**Bulletin | Danfoss Turbocor Compressors**

B-CN-119-CN Rev A

Soft Start Revision and Fuse Addition SUBJECT:

主题: 软启动板修订和增加保险丝

Figure 1 - Revision Identification

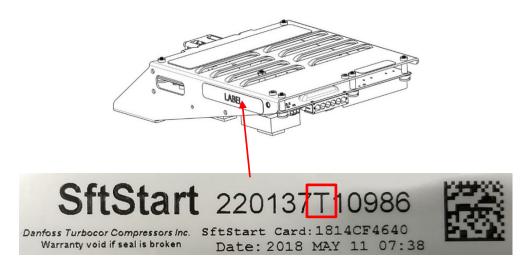
The Soft Start Board part numbers and revisions are identified by a label on the side of the Soft Start mounting bracket. The new revision Soft Start board DTC part number can be identified by the 6-digit part number followed by the revision letter.

Figure 2 – New Fuse Location 图 2 – 新保险丝的位置

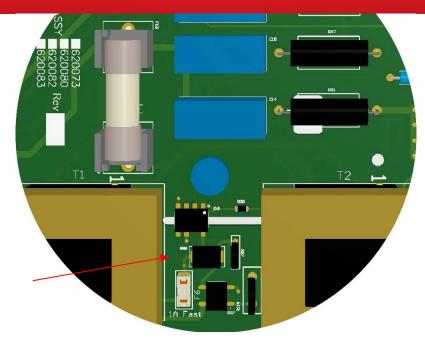
A new fuse has been added to our Soft Starts with revision "T" and later. The new fuse has been added for additional protection of the T1 transformer and to improve the overall reliability of the Soft Start.

This new fuse is a 1A Fast Acting style which is the same as the current F3 fuse. The new F6 fuse is located next to the T1 transformer. Refer to Figure 2 below for an illustration of the F6 fuse location. 新的保险丝与当前的 F3 保险丝一样,为 1A 快速熔断型。新的 F6 保险丝位于 T1 变压器旁边。下面的图 2 显示了 F6 保险丝的位置。
